Addendum 127 – Regulation No. 128

Amendment 1

Supplement 1 to the original version of the Regulation – Date of entry into force:
3 November 2013

Uniform provisions concerning the approval of light emitting diode (LED) light sources for use in approved lamp units on power-driven vehicles and their trailers

Figure 1
Main Drawing – front and side view

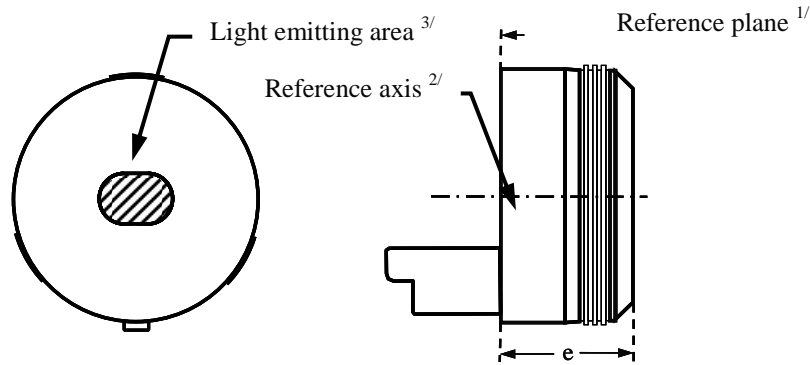
Insert new sheets LW2/1 to 5, to read (see next pages):

The drawings are intended only to illustrate the essential dimensions (in mm) of the LED light source

Figure 3

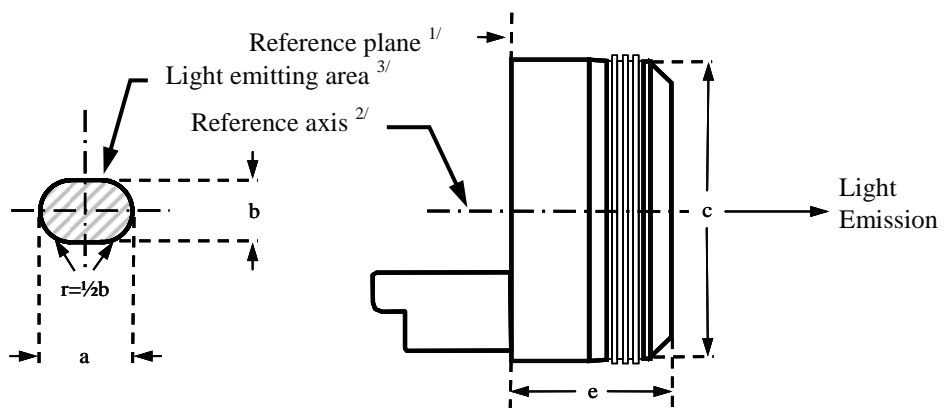
Compliance of position and dimension as defined in Table 2 is checked by the box system shown in Figure 3. The left drawing displays the projection when viewing along the reference axis with an aperture acceptance angle of $\pm 40^\circ$ while the right drawing defines the position of the reference plane and axis.

<i>Dimensions in mm</i>	<i>e</i>	<i>a</i>	<i>b</i>	<i>c</i>
LED light sources of normal production	26.4 ± 0.2	$14.5 +0/-2.5$	$10.1 +0/-1.5$	$\text{Ø } 50.00 + 0.10/-0$
Standard (Etalon) LED light sources	26.4 ± 0.1	$14.5 +0/-2.5$	$10.1 +0/-1.5$	$\text{Ø } 50.05 + 0.05/-0$

Figure 4

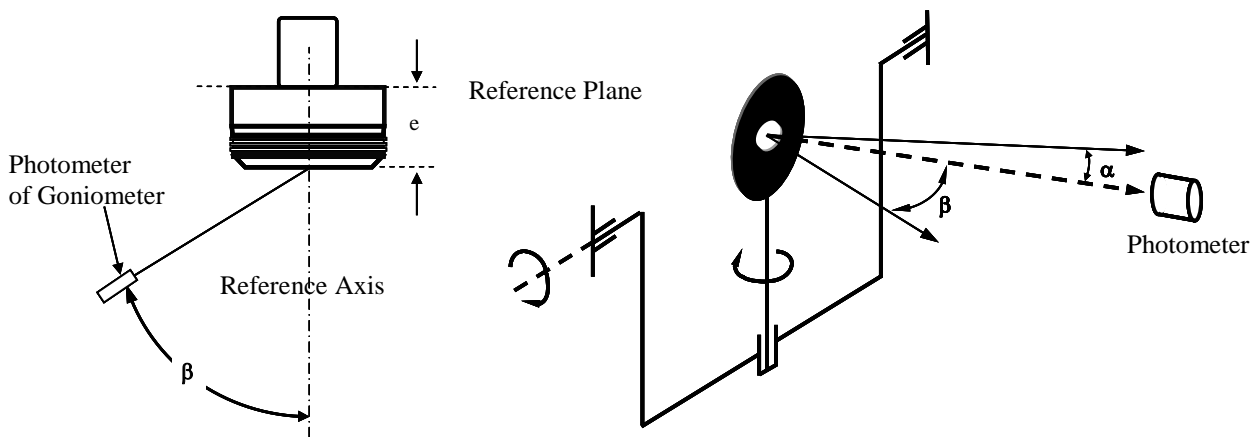
The light source is mounted on a flat plate with the corresponding mounting lug features. The plate is mounted to the goniometer table by a bracket in such way, that the reference axis of the light source lines up with the measurement axis of the goniometer. The corresponding measurement set-up is described in Figure 4.

Figure 5
Rear-view: thermal contact area and location of T_b -point on the vertical symmetry axis, at a distance f from the center

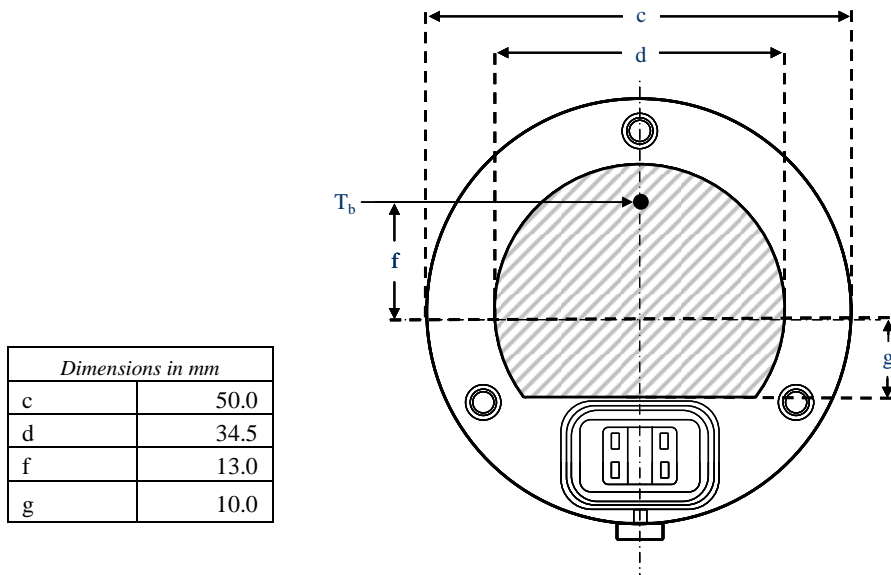
The LW2 thermal interface is located within the reference plane (shaded area in Figure 5) and described in detail in IEC Publication 60061 as indicated in Table 1 on sheet LW2/1. It shall be attached to an appropriate heat sink or thermal management system.

The luminous flux given in Table 1 shall be achieved once the base temperature T_b measured at the location shown in Figure 5 is stabilized.
